DOCUMENT CHANGE REQUEST

DCR number 303 Changes required for: N/A

Title: Transistors High Voltage NPN, based on type 2N5551

Number: 5201/019

1.6.1 Metal Can Package (TO-18) - 3 lead

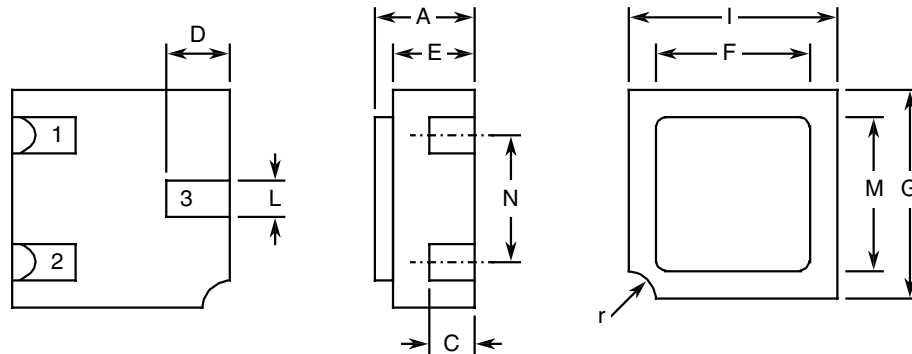
6. Para. 4.3.2 Weight requirements moved to Component Type Variants table.
7. Figure 2 re-named "Physical Dimensions and Terminal Identification"; Figure 2(a) amended to reflect the TO-18 package currently supplied and Figure 2(c) amended to reflect the TO-39 package currently supplied. Notes revised as follows:
